Ofcom fibre costing model

Introduction

As part of the Wholesale Fixed Telecoms Market Review (WFTMR) process, Ofcom developed a costing model known as the fibre costing model (FCM). The model was intended to calculate the costs for Openreach to deploy fibre in Area 3, in case a formal Regulated Asset base (RAB) costing approach was required for the regulation of Openreach's Area 3 wholesale pricing, and as a point of reference for Ofcom's proposed pricing approach for Area 2, where a strict cost-oriented pricing was not proposed.

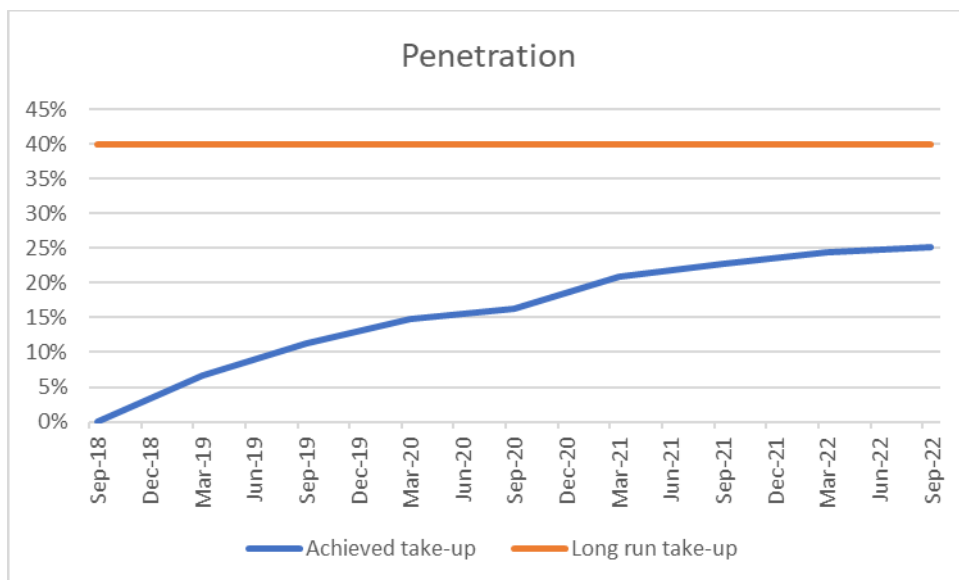
Below is our representation of the Openreach take-up:

This analysis is made by applying a take-up curve to Openreach’s reported FTTP deployments (see table above), with the curve applied from the year in which each deployment started. Openreach has achieved an actual take-up of 27% in aggregate across its FTTP footprint; in this example, a profile with a long run take-up of 40% has been assumed, and in order to match the actual achieved aggregate take-up of 27%, the time to reach 40% in each deployment would be just under three years.⁸

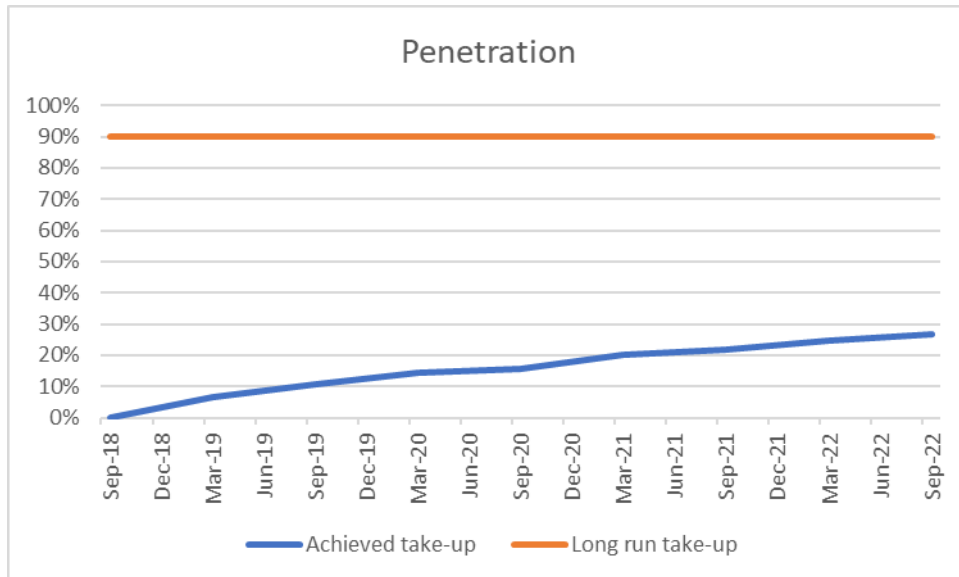
However, we note that Openreach’s deployments to date are typically with zero FTTP competition in the relevant locations and with customers able to move to FTTP without contractual penalties. If, therefore, the long run take-up were to be set at 90% (which is a reasonable assumption given that Openreach is the only FTTP provider in the area), Openreach’s performance to date suggests that it would take seven years to achieve that level of take-up in each deployment. This is illustrated in the chart below.

So, it would seem that Ofcom’s assumption that an REO can achieve the maximum penetration level available (given the number of players in the market) in three years is not even achievable by Openreach despite the significant advantages of Openreach over altnets as set out above.
